Client: VAMC Providence, Rhode Island
830 Chalkstone Ave
Providence, RI 02908

Report: Fire Barrier Wall - Large Opening
VA 241-15-C-0127
PO 650-C58125

Providence VA Medical Center - Fire Barrier Wall Large Opening (Holes) Report

2016.4.April / 02. Second Floor (2 2nd Floor 102015) -

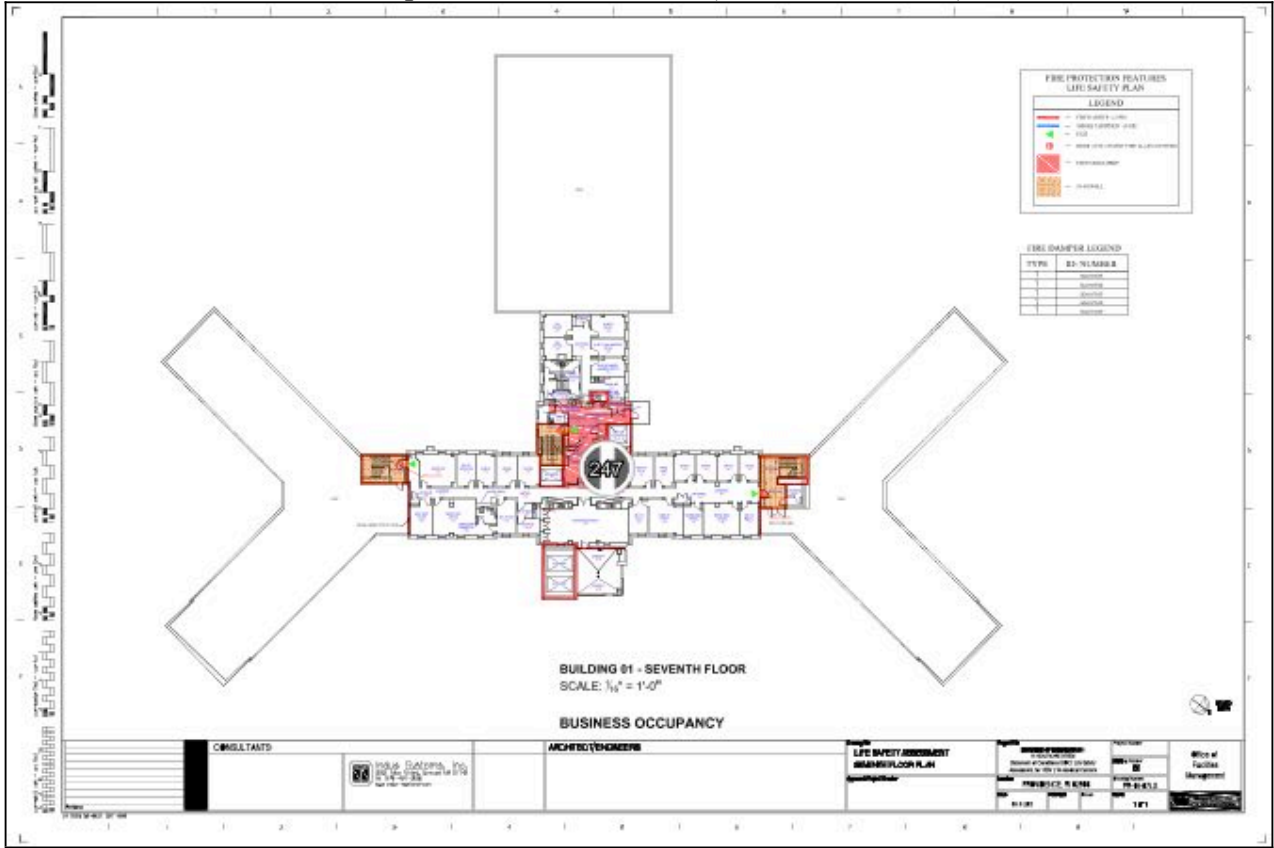
Date Created	EOC ID #	Punch #	Room Number	Type	Item	Wall Material	Fire Rating	Comments	Width (ft.)	Length (ft.)
10/30/15	268629	155	Soiled and O2 215B	Joints	Large Opening	Gypsum	30min Smoke Barrier	Head of wall needs to be properly protected.	.5	10
